UNITED STATES  
NUCLEAR REGULATORY COMMISSION  
WASHINGTON, D. C. 20555

TURKEY POINT PLANT UNIT NO. 3

AMENDMENT TO FACILITY OPERATING LICENSE

Amendment No. 134  
License No. DPR-31

Figure 3.1-1a

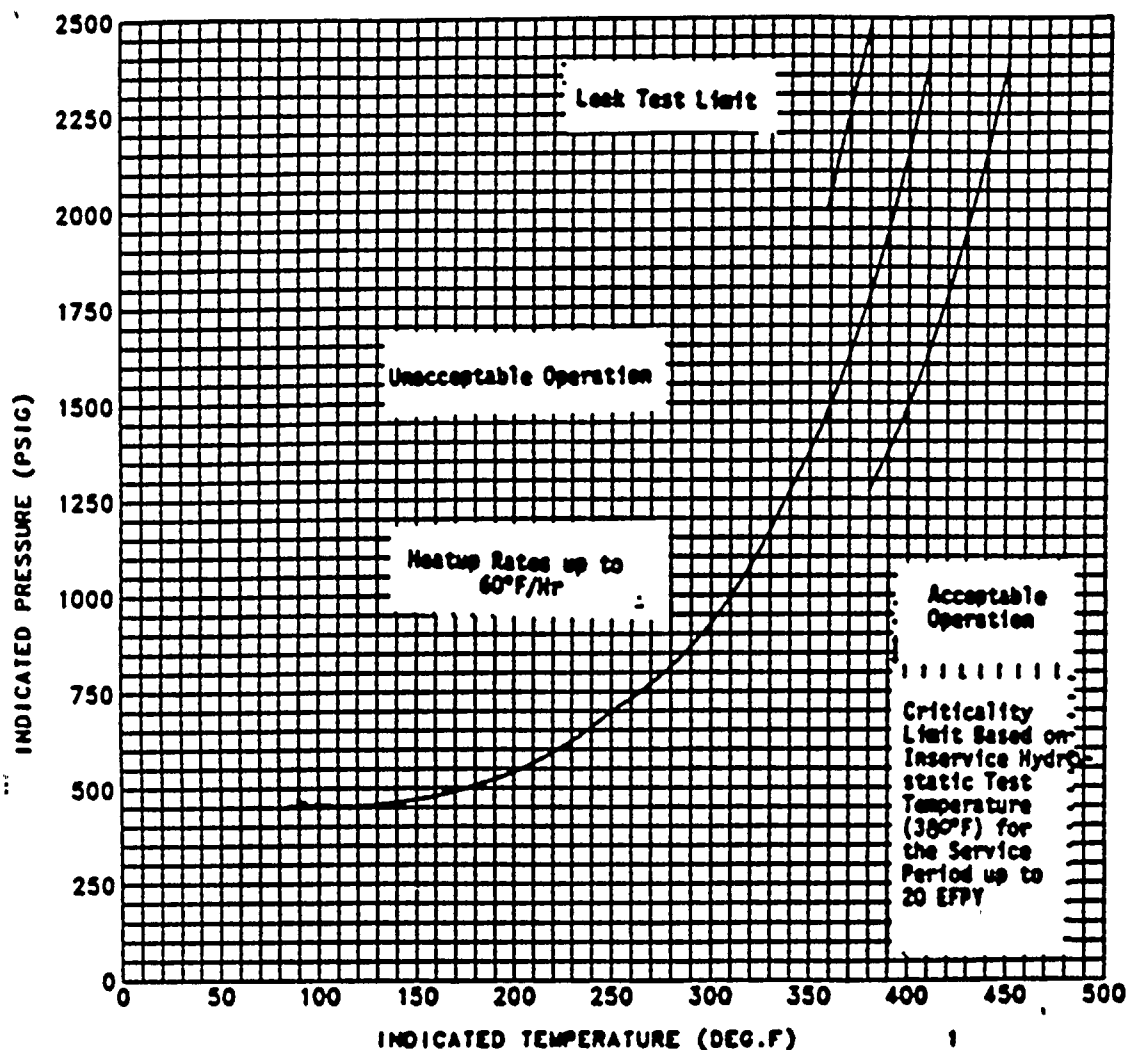
3.1.2a The Reactor Coolant System (except the pressurizer) temperature and pressure shall be limited in accordance with the limit lines shown on Figures 3.1-1a, 3.1-1b and 3.1-1c for both Unit 3 and Unit 4 during heatup, cooldown, criticality, and inservice leak and hydrostatic testing with:

CURVES APPLICABLE FOR HEATUP RATES UP TO 60°F/HR FOR THE SERVICE PERIOD UP TO 20 EPFY. NO MARGINS ARE GIVEN FOR POSSIBLE INSTRUMENT ERRORS.

Figure 3.1-1b

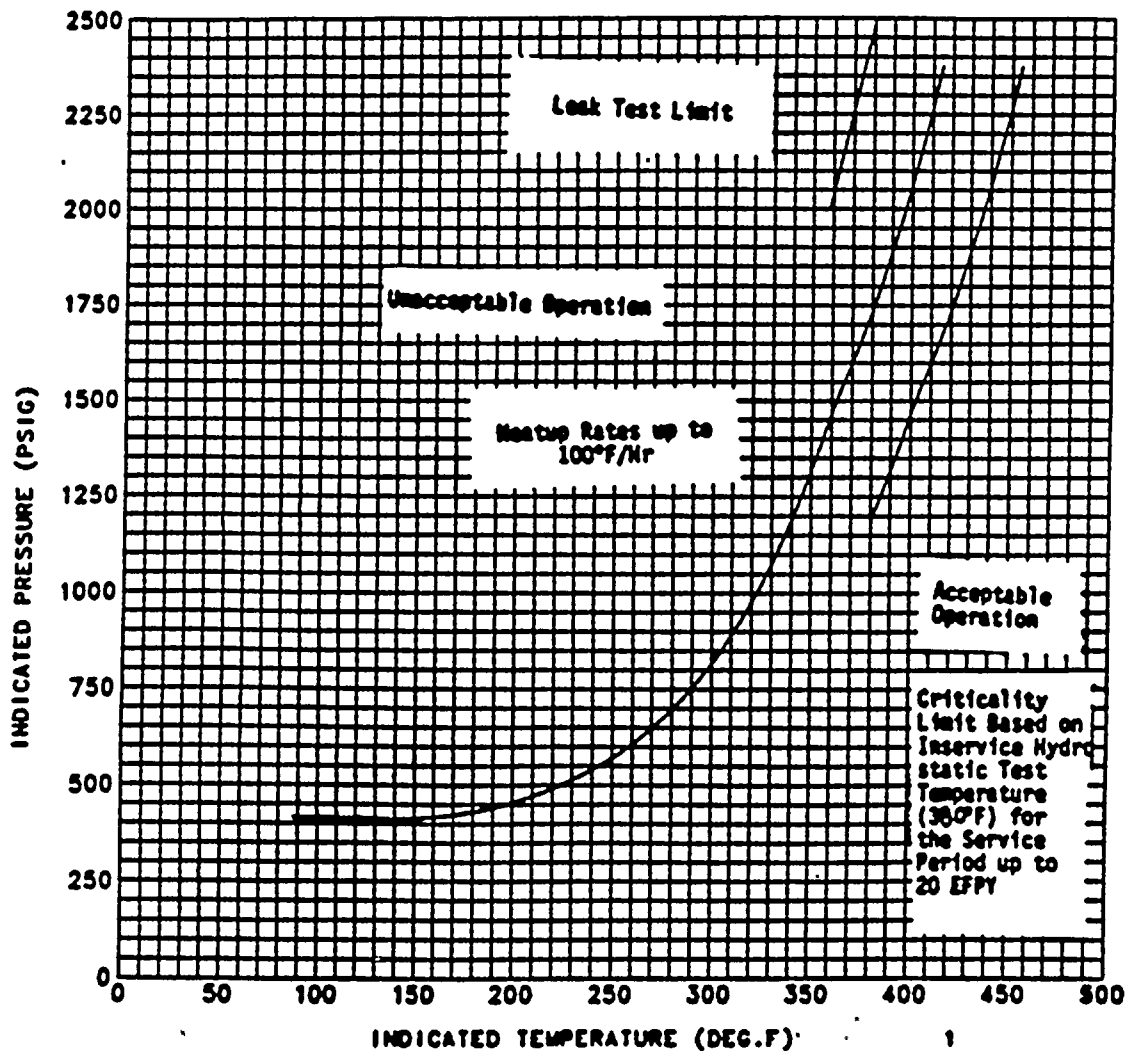
CURVES APPLICABLE FOR HEATUP RATES UP TO 100°F/HR FOR THE SERVICE PERIOD UP TO 20 EPFY. NO MARGINS ARE GIVEN FOR POSSIBLE INSTRUMENT ERRORS.

Figure 3.1-1c

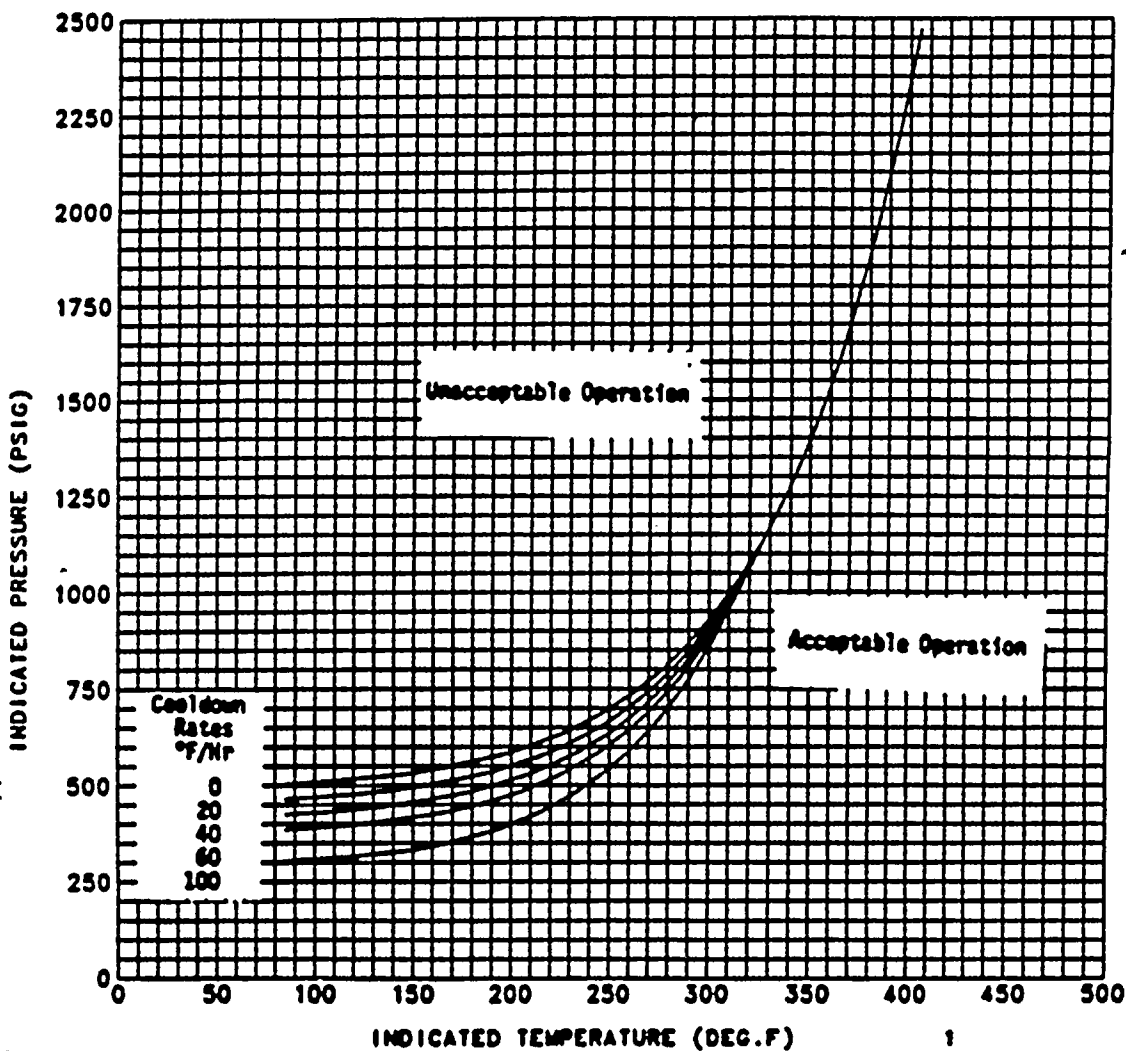
CURVES APPLICABLE FOR COOLDOWN RATES UP TO 100°F/HR FOR THE SERVICE PERIOD UP TO 20 EPY. NO MARGINS ARE GIVEN FOR POSSIBLE INSTRUMENT ERRORS.
